Project: Montauk Point in the Township of East Hampton, Suffolk County, New York, Storm Damage Reduction Project (Project). The proposed Project consists of the construction of a Stone revetment at Montauk Point for protection of Turtle Hill plateau and securing the integrity of the Montauk Point Lighthouse (Lighthouse) and its associated facilities from wave and storm activities.

Re: F-2016-0376
U.S. Army Corps of Engineers
Montauk Point Storm Damage Reduction Project -
Suffolk County, NY
**No Review Necessary - Modification To Previously
Reviewed Activity**

Subject: Montauk Point Storm Damage Reduction Project - Suffolk County, NY

Montauk Point Project Description

Figure 3. HSLRR Revetment Typical Cross Section

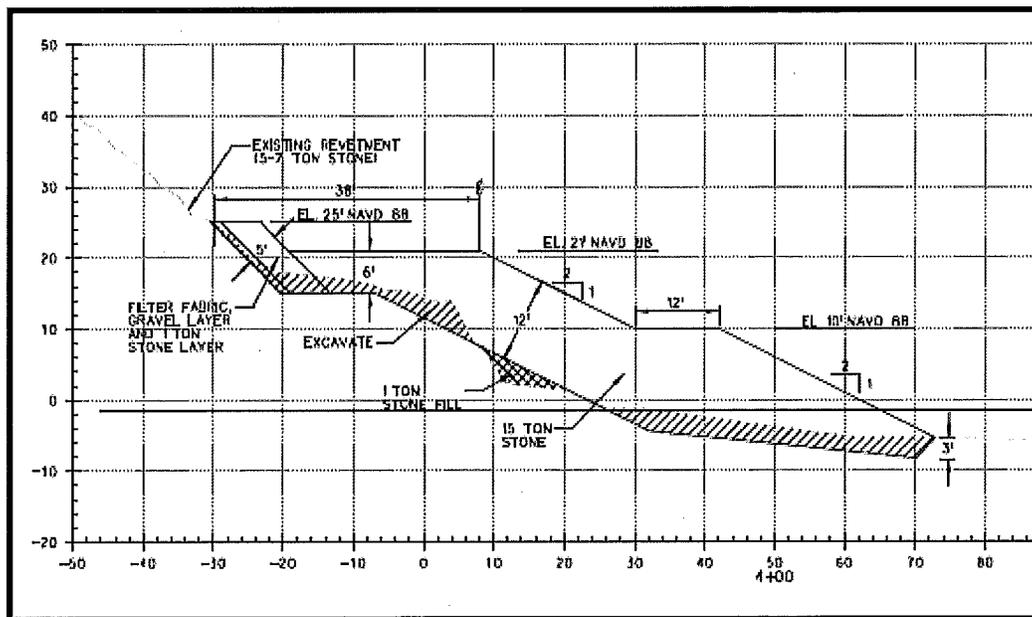
The selected option consists of 15 ton armor stone overlain on the existing 5-7 ton stone revetment. Loose material at the foot of the proposed revetment will be removed to form a stable base and prevent future scour. The revetment slopes from the toe at a 2:1 slope until elevation 10' NAVD88, at which point a 12 foot wide bench is constructed. This bench is located about 8' above mean higher high water. From there, the revetment continues to slope at a 2:1 ratio until reaching elevation 21' NAVD88. The top bench at 21' NAVD88 is approximately 30 feet wide. The final element is a splash apron from elevation 21-25 NAVD88. This element consists of 1-2 ton stone underlain by a geo-textile fabric.

The selected option includes the following refinements from the FS design:

1. Build on top of the existing revetment (5-7 ton stone) instead of removing it. The FS design included the removal of the existing revetment and constructing the new revetment in its place. The HSLRR design will utilize the existing revetment as a foundation for the new revetment. This approach will reduce the amount of stone required, and provide a stronger level of protection. Furthermore, this approach has the added benefit of providing protection for the bluff during the entire construction process.

2. Construct a toe berm instead of a buried toe. The FS design included a buried toe installed to a depth of 16 feet below existing grade. The construction of the FS toe design would be very difficult because the construction will take place approximately 65 feet away from the existing shoreline. In addition, de-watering would likely be required to place the toe, which complicates the construction. The HSLRR design consists of a toe berm constructed at 10 feet NAVD-88 (above Mean High High Water). Minimal excavation will be required (2-4 feet below existing grade) to remove loose material and place the stone. The stone will only need to be placed approximately 40 feet away from the existing shoreline. It is anticipated that the toe berm would be built first to a width of 25 feet to accommodate a crane. The upper part of the revetment would be constructed on top of the toe berm, leaving a 12 foot wide berm to facilitate future maintenance. Excavation material is reduced from about 32,000 cubic yards to about 4,200 cubic yards. Based on soil borings (refusal at 2.5 feet) and observations made during site assessment, the existing material provides an adequate base. The toe berm design also reduces the amount of armor stone required.

3. Use 15 ton stone instead of 12.6 ton stone for armor stone. While 12.6 ton stone is adequate for the design wave height of 13.4 feet under current conditions, the water depths in front of the structure are anticipated to increase throughout the project life (thus increasing the design wave height) due to both erosion and sea level change. The selection of 15 ton stone results in increased strength without having to upgrade to special heavier duty equipment for stone handling and placement. In addition, the larger stone size increases productivity because a lower number of stones are required to be placed resulting in a shorter construction duration. Lastly, the larger stone will stay in place better, reducing future maintenance requirements.

4. Lower crest to 21 feet NAVD-88 instead of 24 feet NAVD-88. The reduced elevation of the crest reduces the amount of armor stone required, while still providing adequate protection against wave over-topping. This is achieved by an extra wide crest (approximately 33 feet). To provide an additional layer of protection against overtopping, a five foot layer of 1-2 ton stone is placed from 21' NAVD88 to 25' NAVD88. See the Coastal Engineering Appendix for additional details on this analysis.

Figure 4. Comparison of FS and HSLRR - Cross Section (Typical)

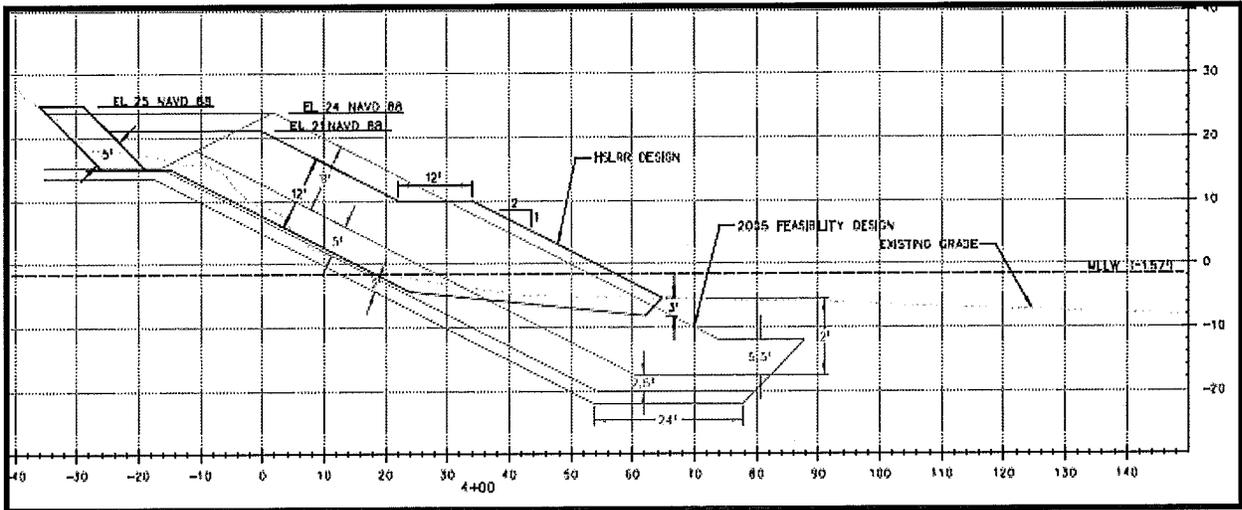
Below is a comparison of the FS and HSLRR Cross Section and Plan View (Figures 4 and 5):

As noted above, the HSLRR design refinements result in a smaller footprint of impact than the FS. The HSLRR design does result in a slighter greater impact at the Mean Low Low Water interface. A summary of the key parameters of the FS design and the HSLRR refinements are provided in the table below (Table 1):
